DEVELOPMENT REVIEW BOARD
SUPPLEMENTAL SUBMITTAL

PROJECT NO. PR-2021-006238
Application No. SI-2021-01916 and SD-2022-00001

Memorandum

Re: Allaso Louisiana Site Plan – DRB Comment Responses (PR-2021-006238)

SHEET NUMBER:
C-104

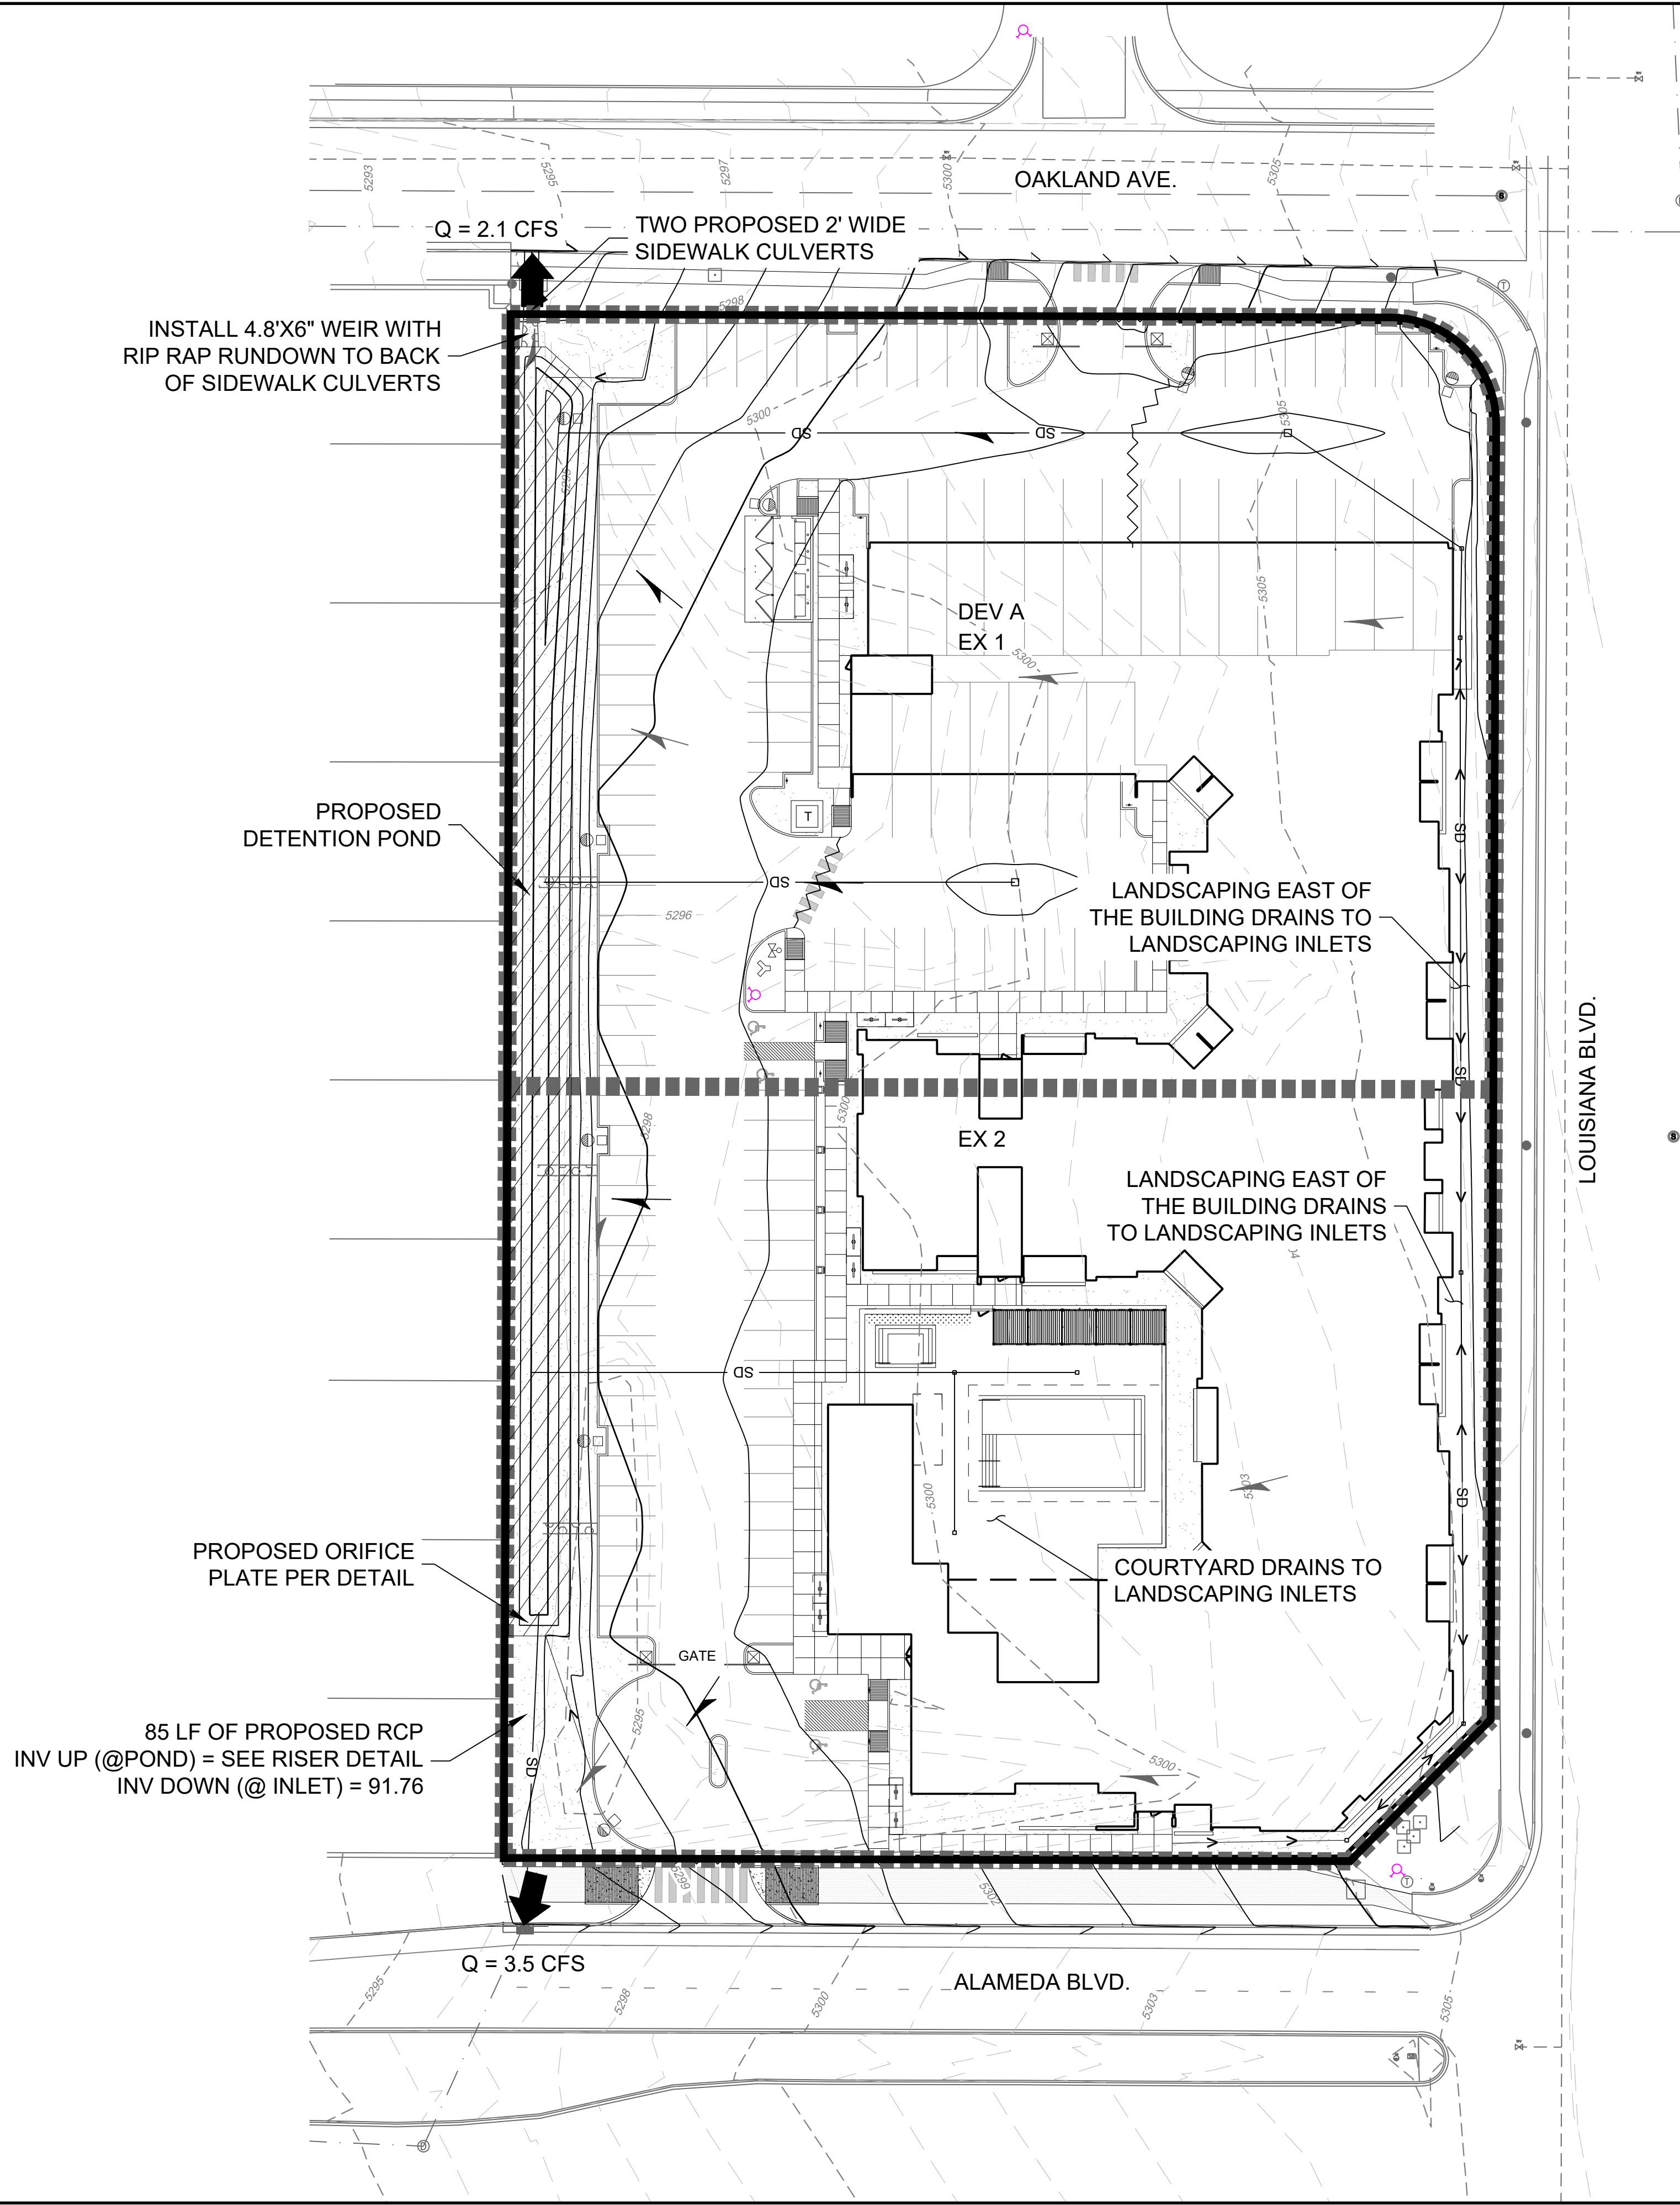
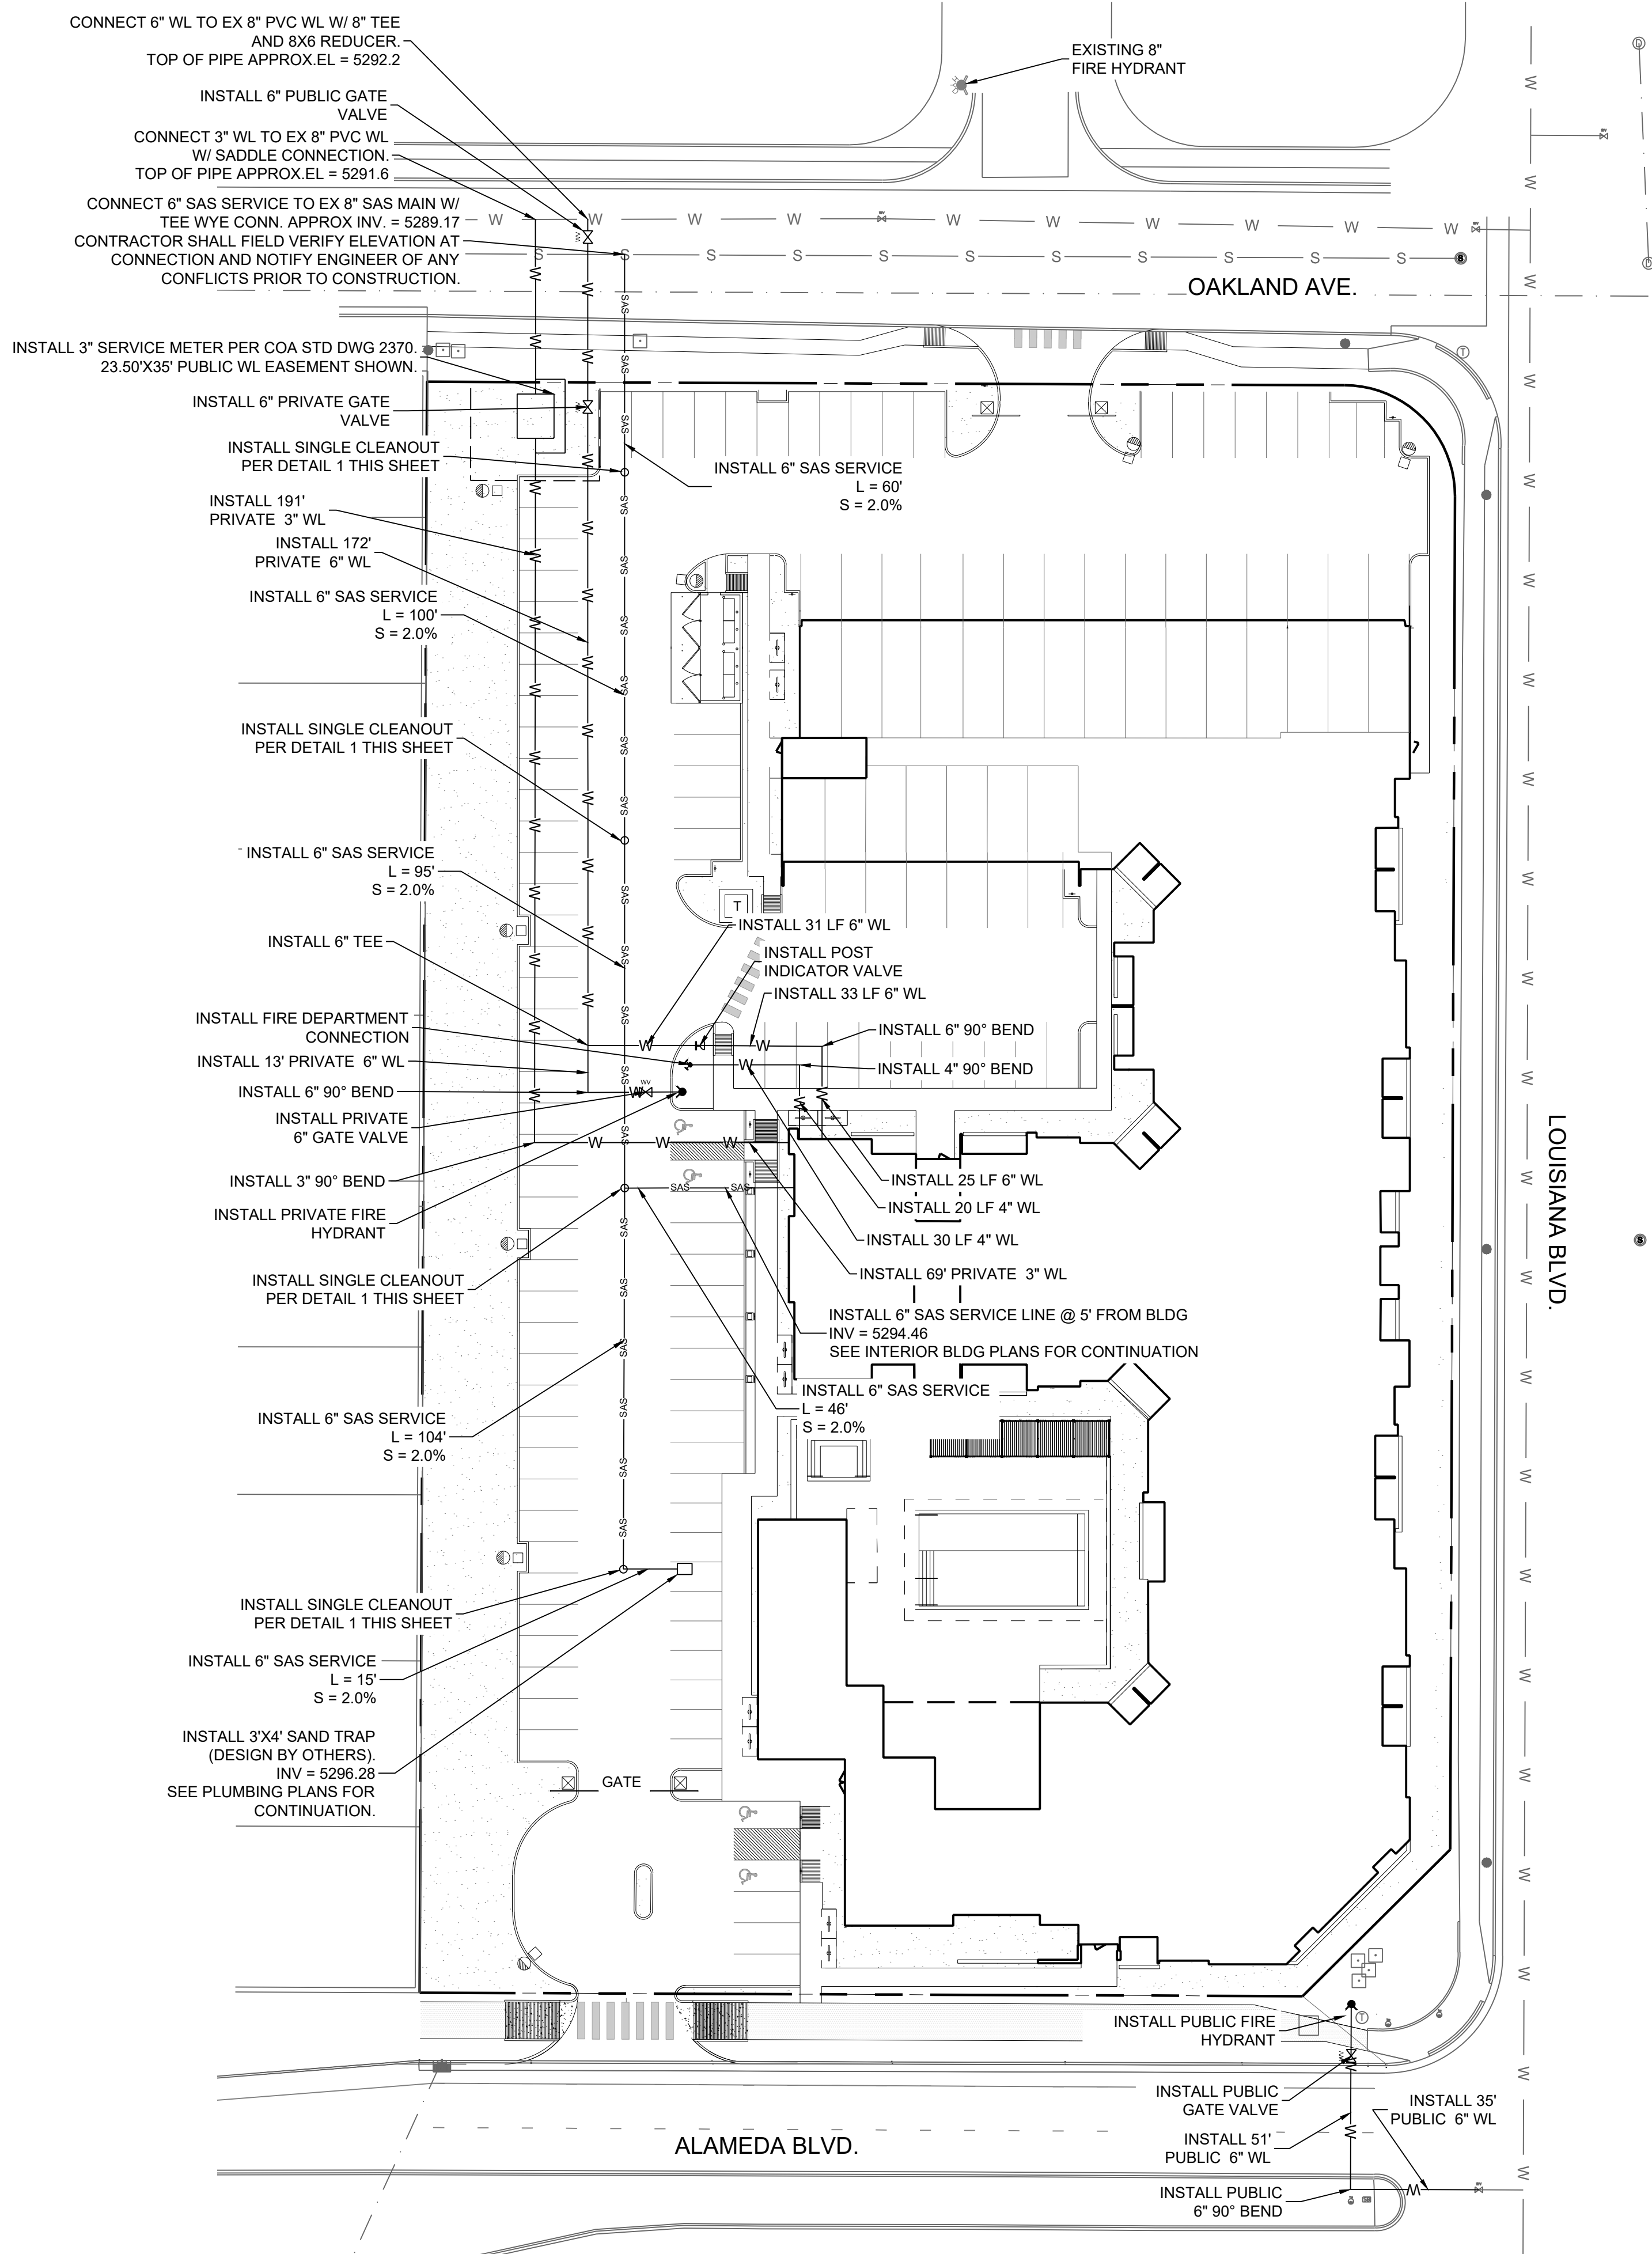
1. Hydrology did receive the submittal on 11/11/2021 (C18D085). Hydrology had a minor comment about Stormwater Quality Volume. Once the Engineer fixes the Grading & Drainage Plan, Hydrology will approve it.
 - a. ***The grading and drainage plan has been updated to account for the required Stormwater Quality Volume.***

Water quality requirements will be met by retaining the required water quality volume in the pond below the orifice of the outlet pipe (see the pond riser detail). Calculations for the required water quality retention volume can be found on this sheet.
